UNITED STATES
NUCLEAR REGULATORY COMMISSION
WASHINGTON, D. C. 20555

October 22, 1979

SUBJECT: NRC REQUIREMENTS FOR AUXILIARY FEEDWATER SYSTEMS AT FORT CALHOUN STATION UNIT NO. 1

AUXILIARY FEEDWATER SYSTEM

Auxiliary Feedwater System
Ft. Calhoun
Figure 1

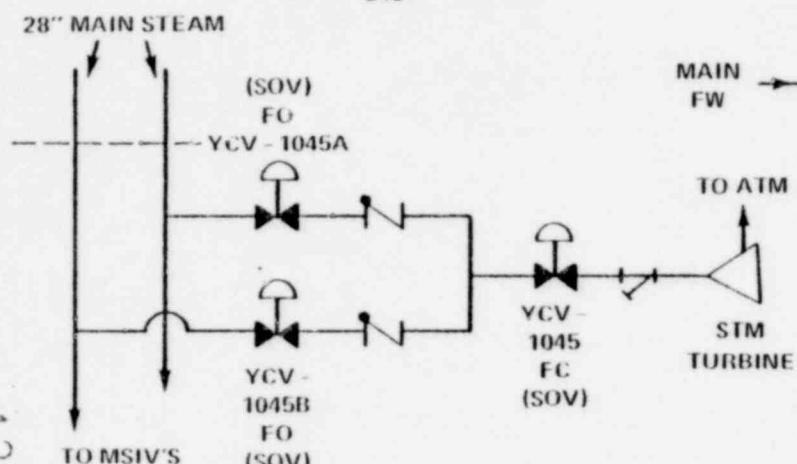
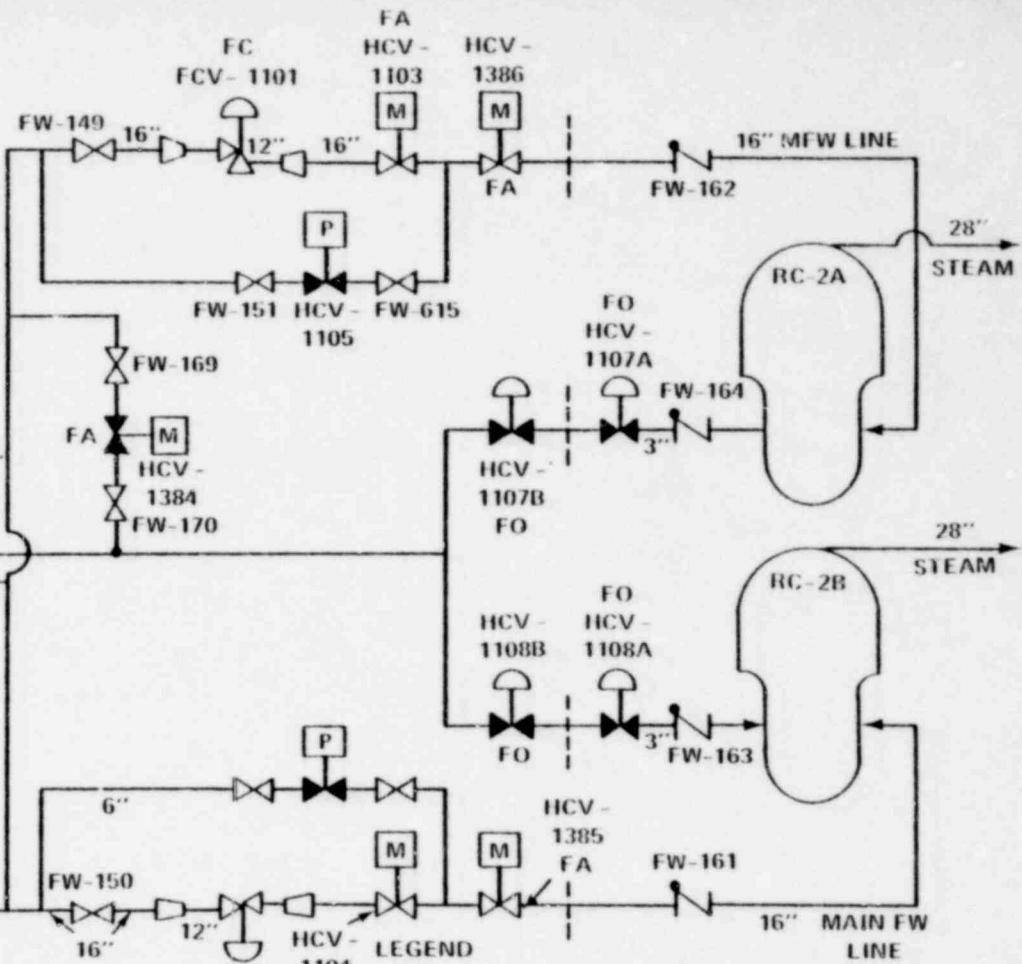
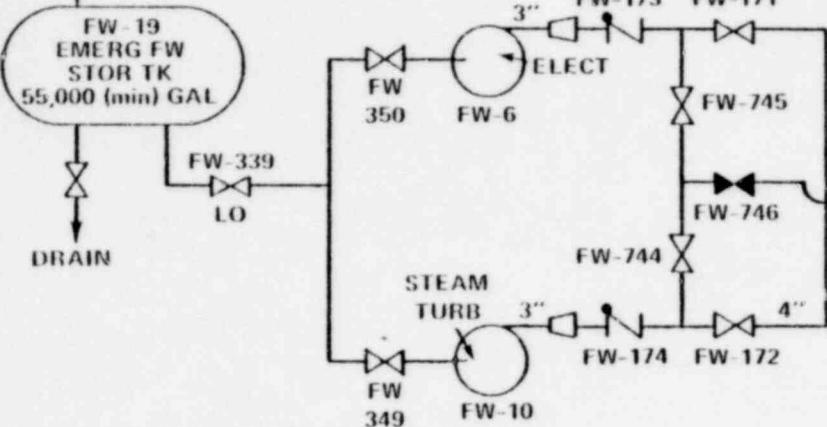
The steam turbine driven pump receives steam from either SG from a point upstream of each main steam isolation valve (MSIV) via direct current (DC) power solenoid air operated valves and exhausts directly to the atmosphere. (See Figure 1 for valve(s) normal position and position upon loss of power or air.)

The dominant failure mode (~ 80% contribution) identified for the Ft. Calhoun AFWS was inadvertent closure of the single, manually operated AFW pump suction valve from the LFST that could make the redundant AFWS subsystems inoperative. Although this valve is located in a security area and is visible and locked open, the licensee plans to further strengthen the administrative checking on this valve and its position status, (i.e., a visual check would be made and logged as part of a routine data logging procedure performed for the turbine and steam plant). This added procedure

An additional potential vulnerability of the Ft. Calhoun AFWS design was observed; however, this vulnerability was not assessed in detail during this review. This potential vulnerability is associated with the discharge piping cross-connection between the two AFWS subsystems that includes two normally open manual valves (FW 744 and FW 745). This cross-connection was installed by the licensee subsequent to the FSAR review to provide an alternate way to supply AFW flow via the main feedwater system. A single passive failure in this cross-connection would require local operator action to manually close either FW 744 or FW 745 to isolate the two subsystems from one another. The licensee should re-evaluate the position of these valves considering a postulated break in the cross-connection (see short-term recommendation number 6.)

2. The potential common mode vulnerability in the cross-connection installed by the licensee due to valves FW 744 and FW 745 being left normally open. Failure in the cross-connection requires local manual actions to correct.
3. The operator being required to connect the motor-driven pump train of AFWS to an EDG bus for the LOFW transient with only onsite AC power available.

6. Since valves FW 744 and 745 in one of the AFW pump discharge headers are normally open (see Figure 1), a postulated break in this header would cause loss of the capability to provide AFW flow to both steam generators. The licensee should re-evaluate the position of these valves considering such a postulated pipe break to revise the valve alignment to reduce the impact of such an event on the AFW capability (e.g., close valves FW 744 and FW 745).

- a. The discharge lines of both AFW pumps combine into a single header through which all AFW water must flow. A pipe break in this single flow path could result in the loss of the entire AFW system function.
- b. The Ft. Calhoun AFW system design does not meet the high energy line break criteria in SRP 10.4.9 and Branch Technical Position 10-1; namely, that the AFW system should maintain the capability to supply the required AFW flow to the steam generator(s) assuming a pipe break anywhere in the AFW pump discharge lines concurrent with a single active failure.

The licensee should evaluate the postulated pipe breaks stated above and (1) determine any AFW system design changes or procedures necessary to detect and isolate the break and direct the required feedwater flow to the steam generator(s) before they boil dry or (2) describe how the plant can be brought to a safe shutdown condition by use of other systems which would be available following such postulated events.
